Site Package Part B, 220 KV Cable Work for 400/220 KV Prayagraj (Allahabad) Sub-station Extension (SS-119);GEM/2024/B/5170517

Sl. No.	Tender Reference	Tender Clause	Bidder's Query	Powergrid reply
1	Section-III: Bid Data Sheets, Clause No. 4, Bid Prices	Prices quoted by the Bidder shall be FIRM and FIXED. No price variation shall be applicable to the prices during the currency of the contract.	Section-VI: Sample Forms and Procedure incorporates Price Adjustment as per Appendix-2 which is contradictory to Clause No. 4 of Section-III which states that the prices shall be Firm & Fixed. Apart from this GeM Bid Document also states that the Price Variation is applicable for this Tender, therefore, please confirm that Price Variation is applicable for the tendered 220kV 1Core 2500 sqmm cable as per the Formulae specified in Appendix-2.	Price variation is applicable. Clause 4 of BDS may be read as "Bids shall confirm to the price adjustment provisions as detailed in appendix-2, Forms and procedures, Conditions of Contract".

TENDER DRAWING
NR-3/ENGG/220kV CABLE/Rev-01
TITLE: BURIED CABLE TRENCH SECTION

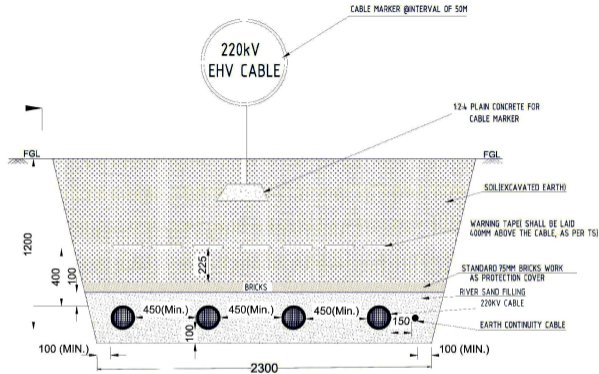
Sl. No.	Tender Reference	Tender Clause	Bidder's Query	Powergrid reply
17	Qualifying Requirement, Technical Experience, Clause 1.1(a)	The bidder must have designed, manufactured, type tested and supplied cumulatively at least 05 (five) km of single core 220kV or higher grade XLPE insulated cable which must have been in satisfactory # operation for at least 2 (two) years as on the originally scheduled last date of bid submission (soft copy) i.e. 16.08.2024.	We have a type test of 220kV 2500sqmm Al conductor Corrugated Al Sheath Cable. Pl confirm whether the same would be applicable for this tender or not.	Valid Type Test Report as per the (Range of Type Test Approval) as per IEC 62067 clause 12.2 is required to be submitted for Copper Conductor cable.
18	Cross-section drawing of Road/Trench Crossing	Drawing attached in tender	Pl provide complete details in the cross-section of road/trench crossing drawing attached. Cross sectional detail for 1000mm section is not clear in the attached drawing.	Tender Drawing NR-3/ENGG/220kV CABLE/Rev-01 for Buried Cable Trench Section is attached.

HDPE Pipe to be provided for EOC cable also double size of diameter of ECC
